DESIGNED BY DLF
DRAWN BY DLF
CHECKED BY QNA
H-SCALE AS SHOWN
V-SCALE N/A
JOB NO. 2604.00
DATE ISSUED 04/03/26
SHEET NO. 2 OF 36

WATERBURY SANITARY FORCE MAIN
UTILITY CONSTRUCTION SET
LEGEND SHEET

WATERBURY SANITARY FORCE MAIN
 UTILITY CONSTRUCTION SET
 EROSION CONTROL PLAN - INITIAL/INTERIM

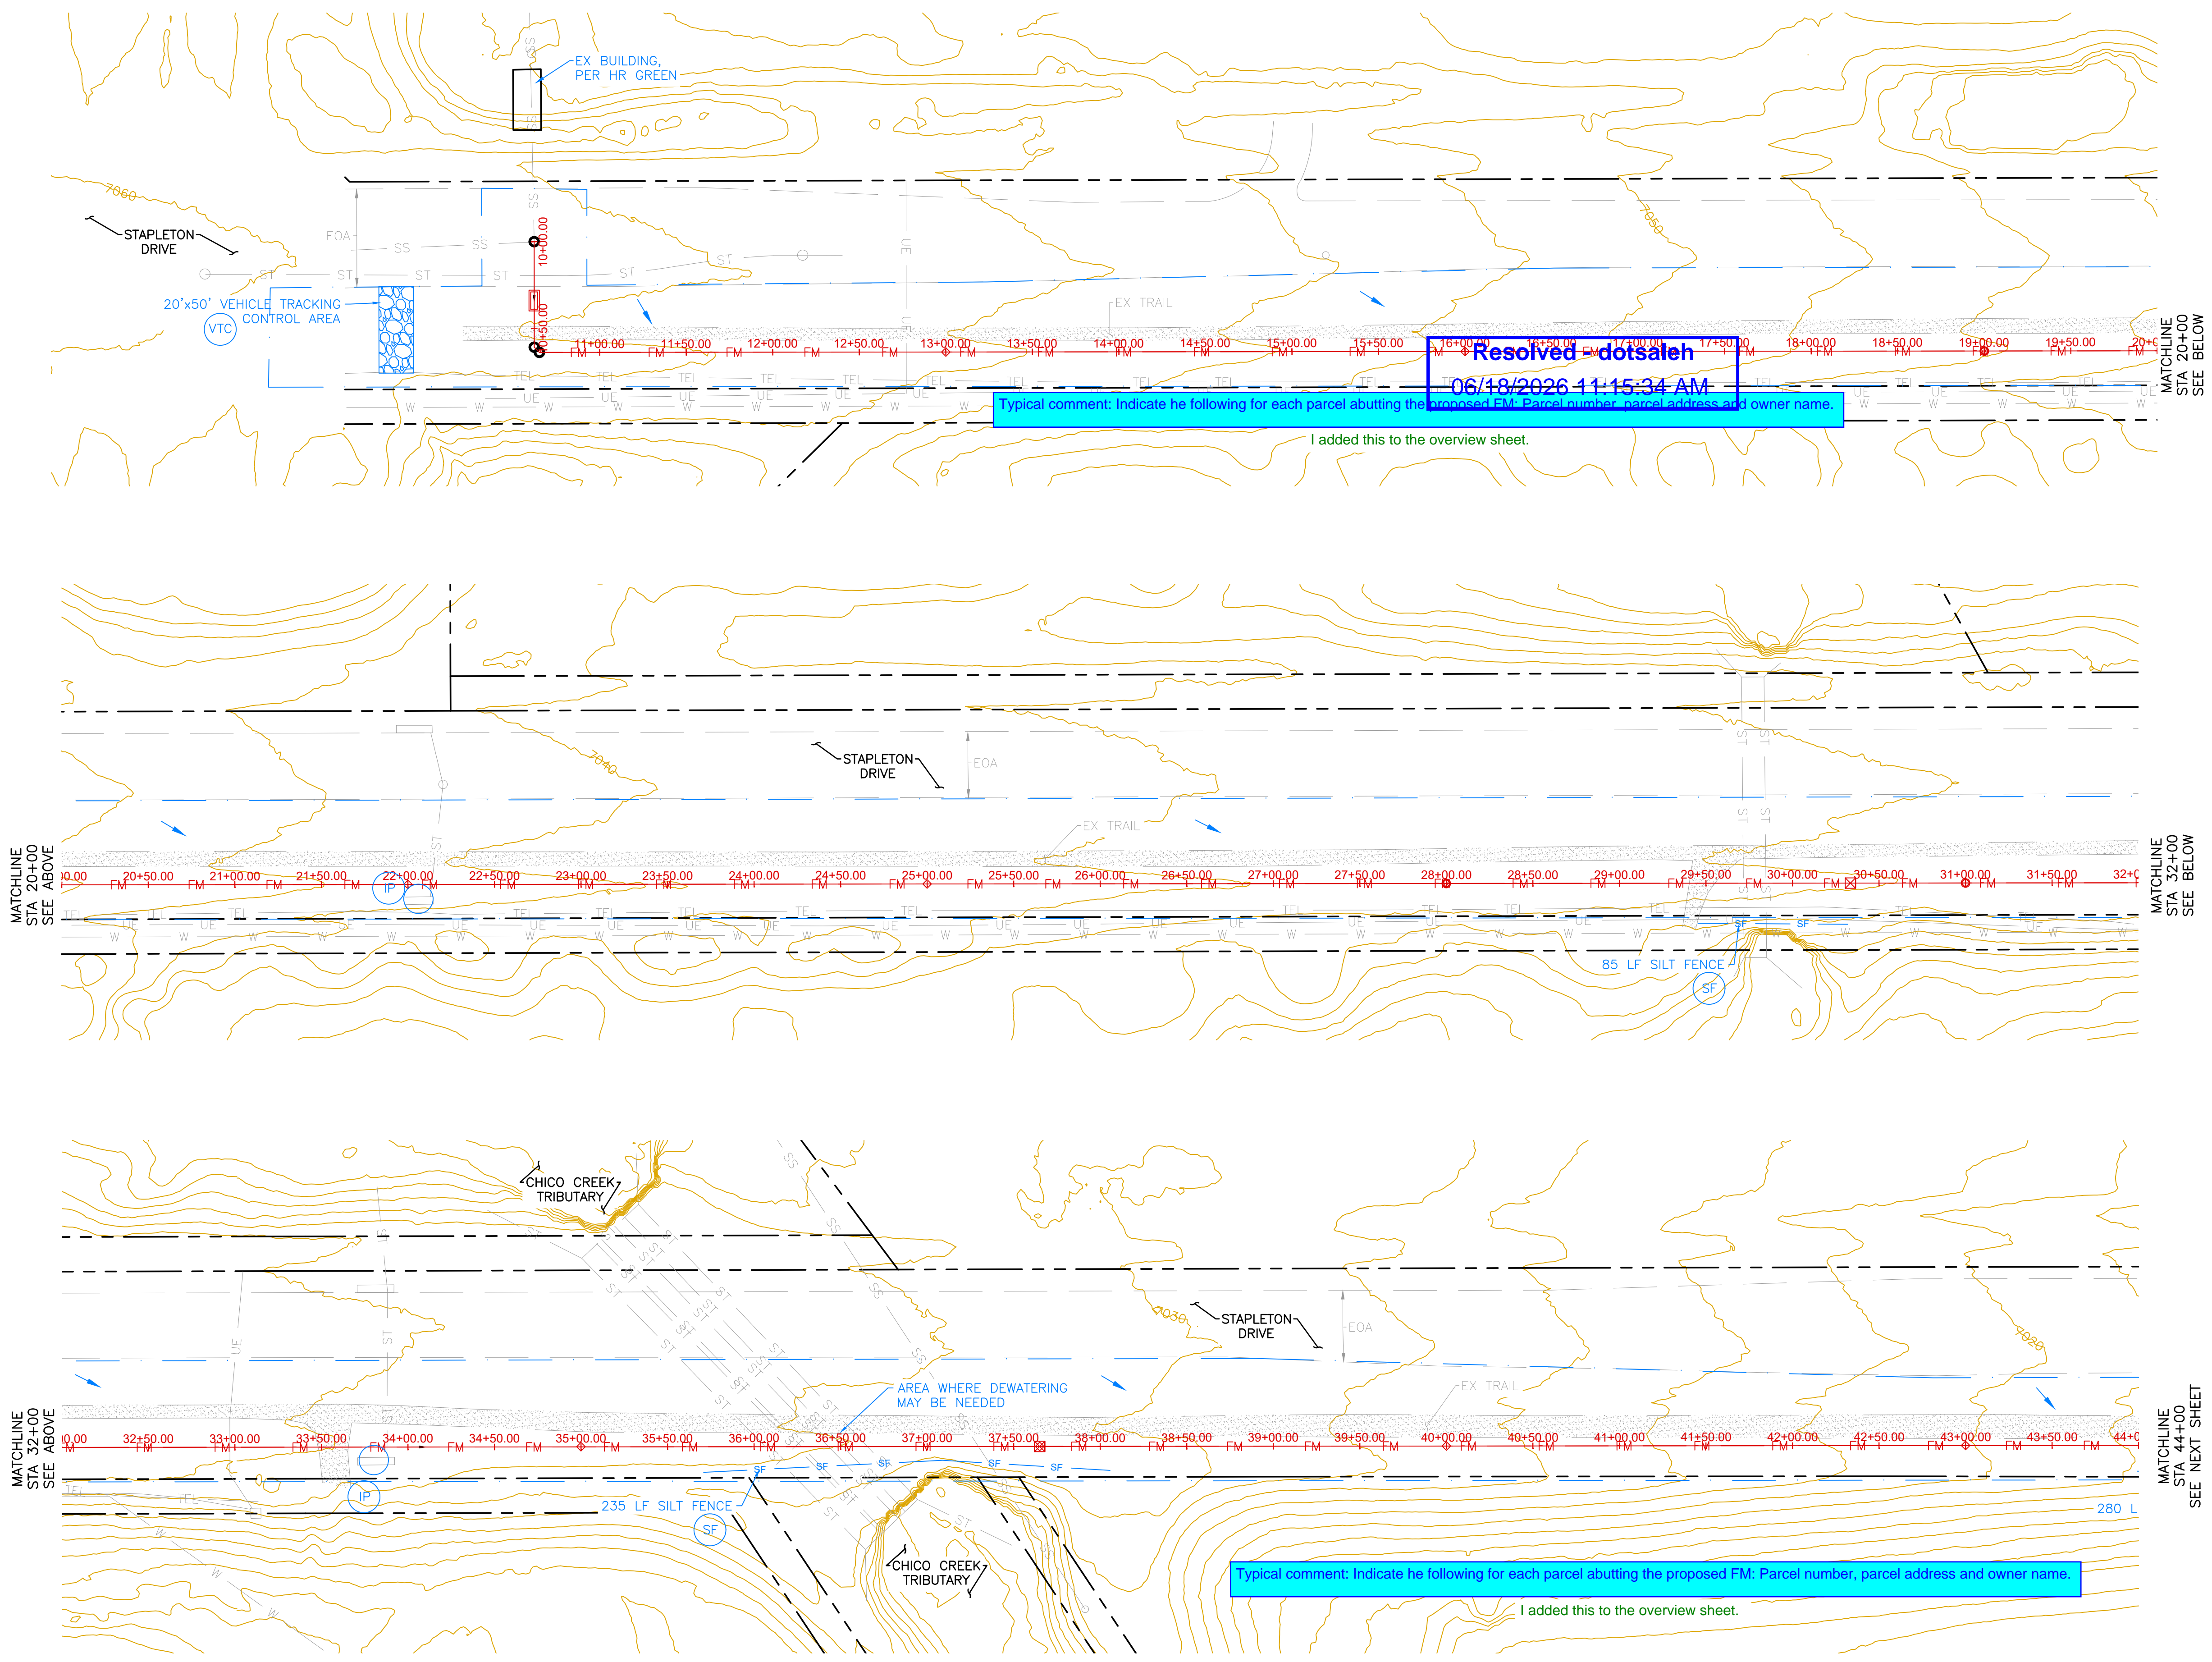
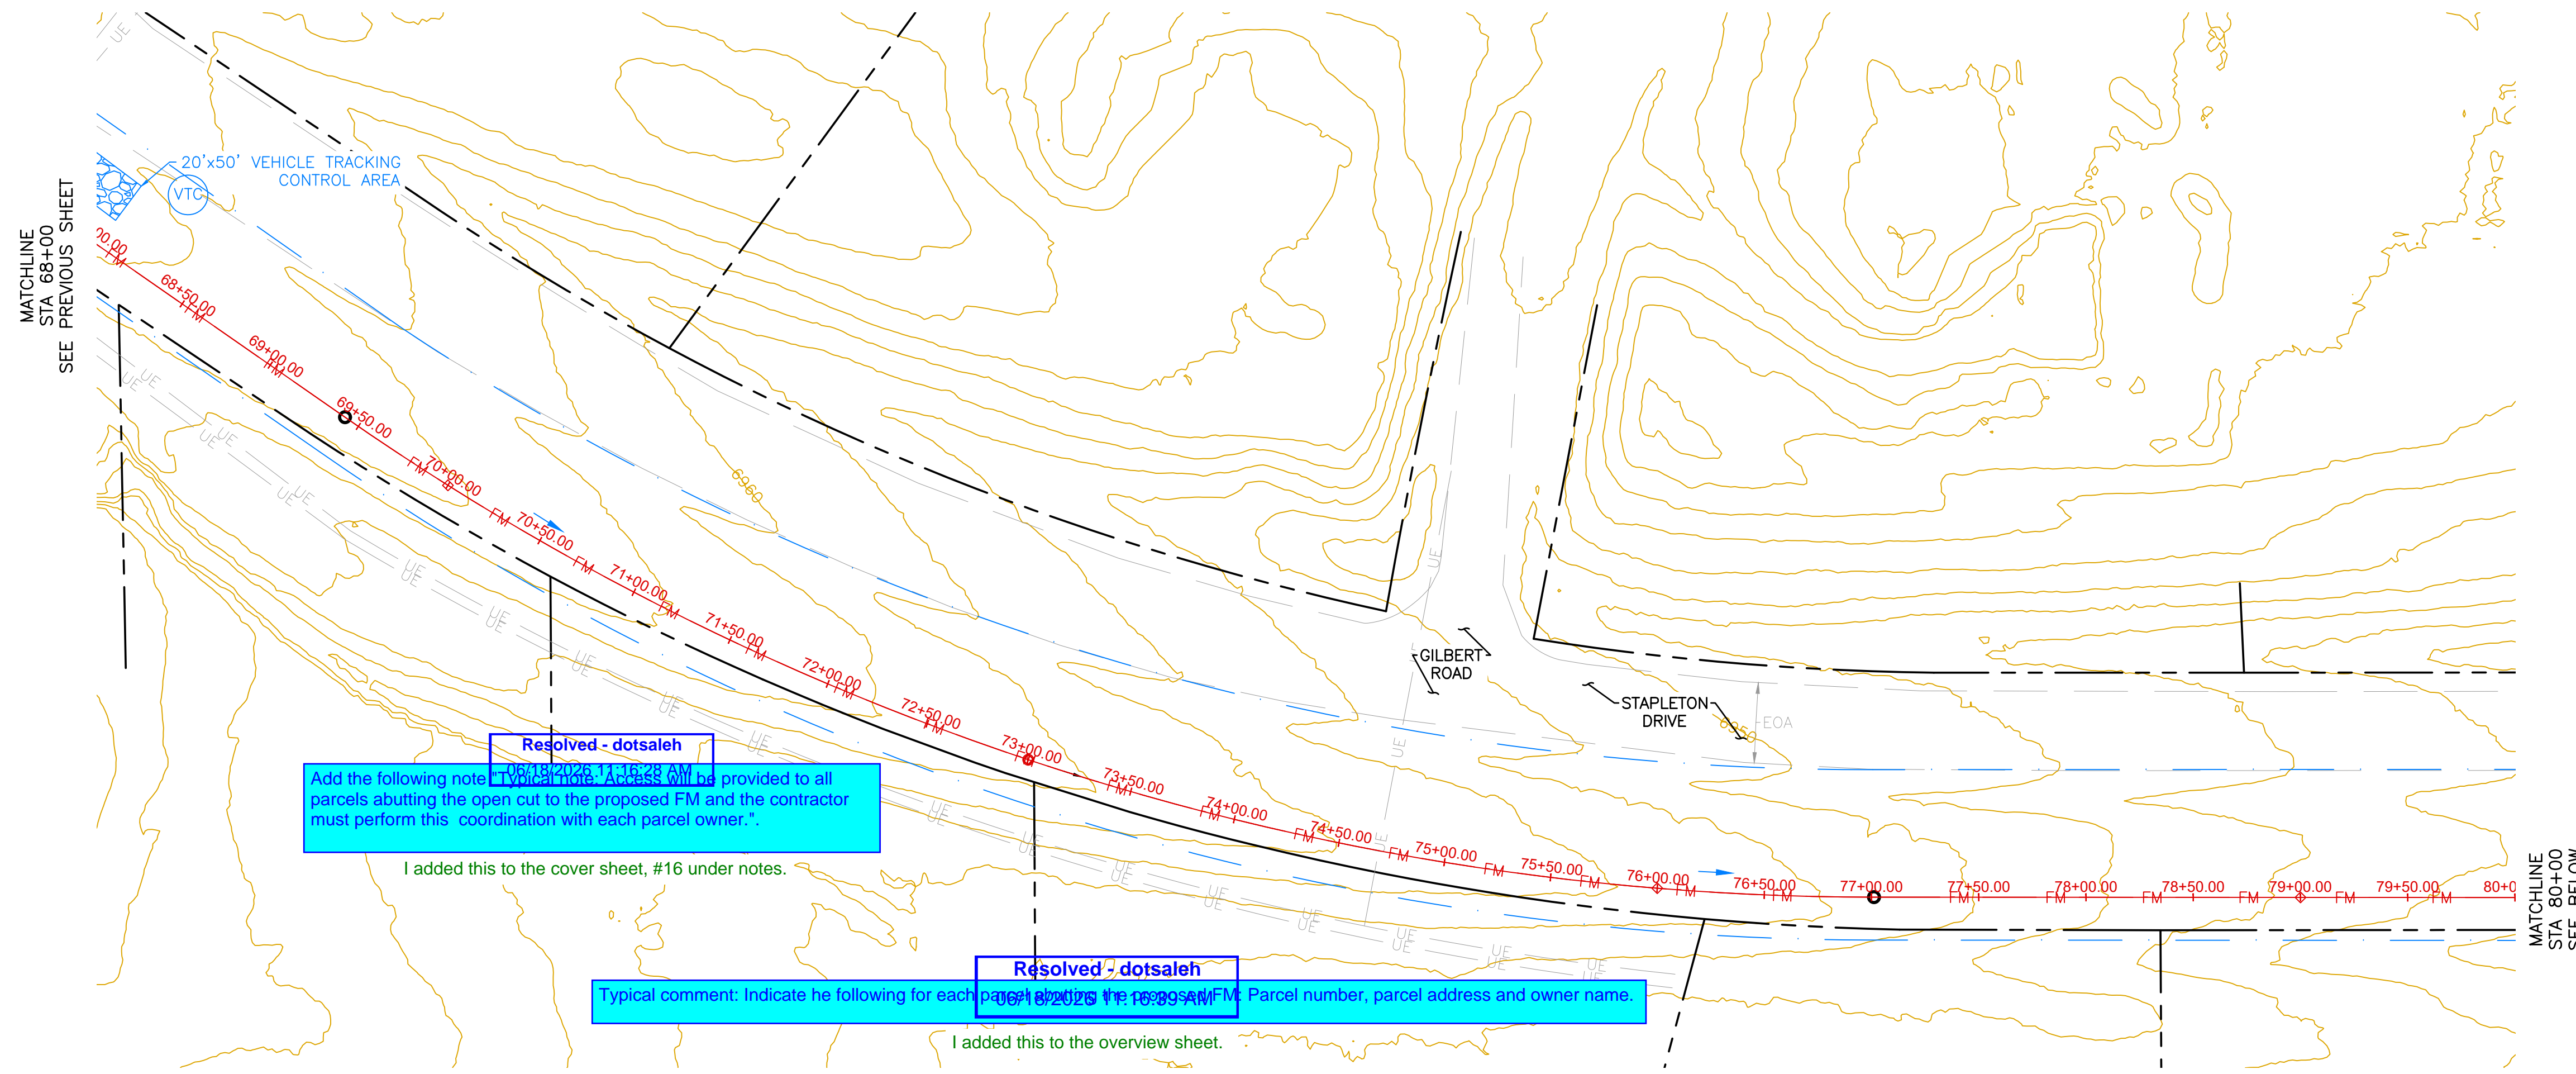
Resolved - dotsaleh
 Add the following note to the cover sheet: Access will be provided to all parcels abutting the open cut to the proposed FM and the contractor must perform this coordination with each parcel owner.
 I added this to the cover sheet, #16 under notes.

WATERBURY SANITARY FORCE MAIN
 UTILITY CONSTRUCTION SET
 EROSION CONTROL PLAN - INITIAL/INTERIM

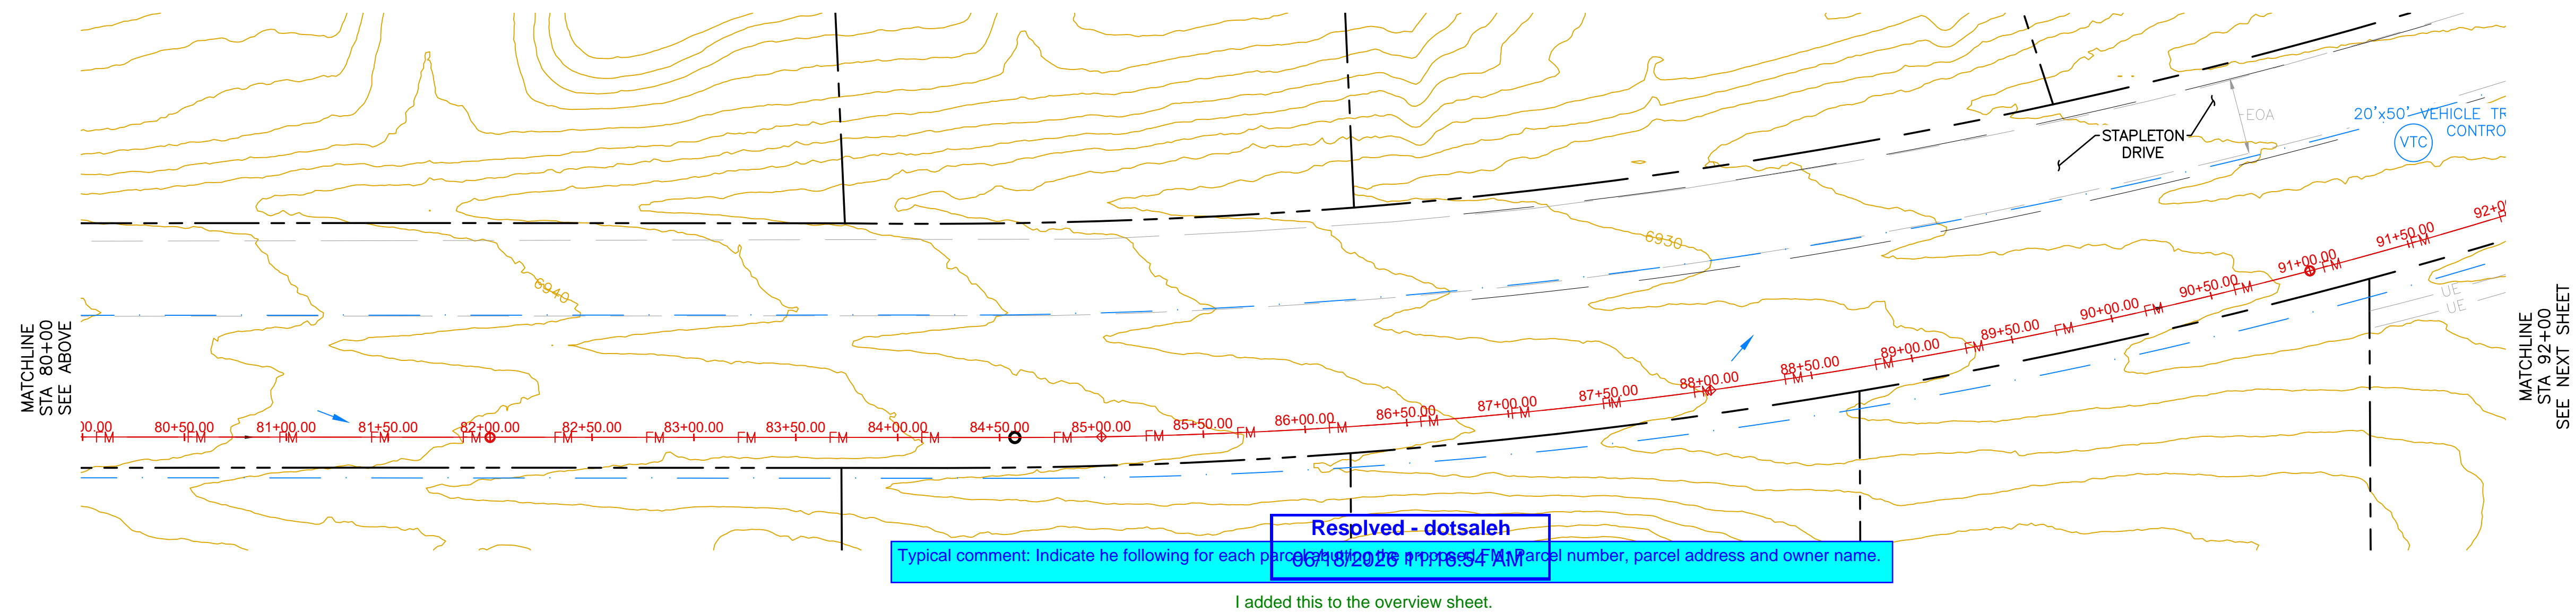
Resolved - dotsaleh
 Typical comment: Indicate the following for each parcel: Parcel number, parcel address and owner name.
 I added this to the overview sheet.

Resolved - dotsaleh
 Typical comment: Indicate the following for each parcel: Parcel number, parcel address and owner name.
 I added this to the overview sheet.
